**URGENT FIELD SAFETY NOTICE**

**FSCA Reference:** 1427918 - Bubble Sensor - Bad contact in sensor cable

**Affected Product:** BS 3/8x3/32 L1.7 Mat. 701055720  
(Bubble Sensor for 3/8" x 3/32" tubing, length 1,7 m)

Figure 1 Picture of a Venous Bubble Sensor

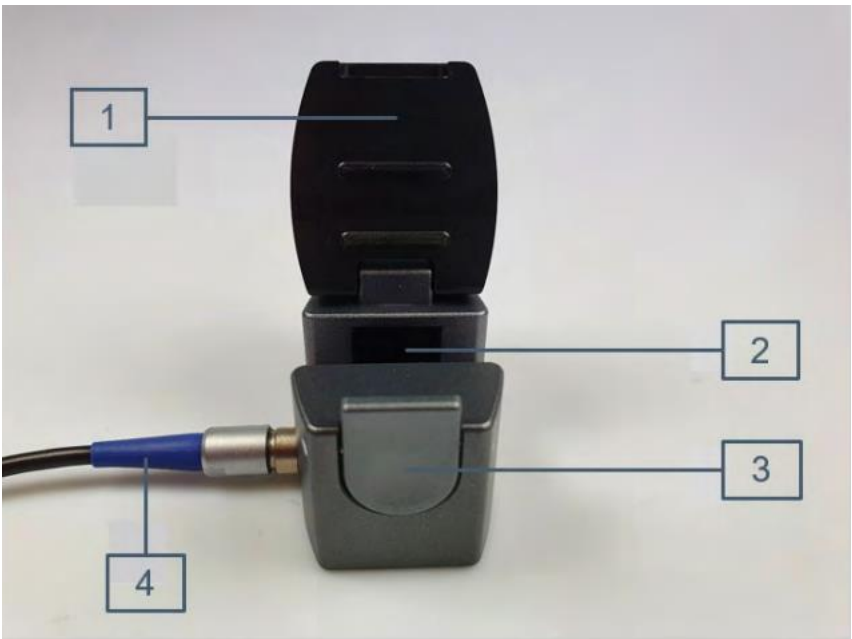
Internal investigations have identified an issue with the durability of the connecting cable (See Fig. 1 position [4]) near the connection to the Bubble Sensor. Excessive bending of the cable can lead to poor contact, which may trigger the errors “Ven. bubble sensor defective” or “Ven. bubble sensor disconnected” on the connected medical device (ROTAFLOW II or CARDIOHELP-i). These errors can occur temporarily when the cable is moved or permanently if the connection is fully compromised.

- **The Venous Bubble Sensor remains functional until error** (“Ven. bubble sensor defective” or “Ven. bubble sensor disconnected”) displays on the main device.
- **To prevent error occurrence please follow these guidelines when handling Venous Bubble Sensors:**
  1. **Avoid roll up or coiling of the sensor cable!** When storing affected products, place them loosely in a box or bag to prevent damage.
  2. **Avoid excessive bending** of the Venous Bubble Sensor.
  3. **Handle the Sensor cable with care during cleaning.** Do not pull with excessive force while wiping the cable.

**Replacement of affected with unaffected devices.**
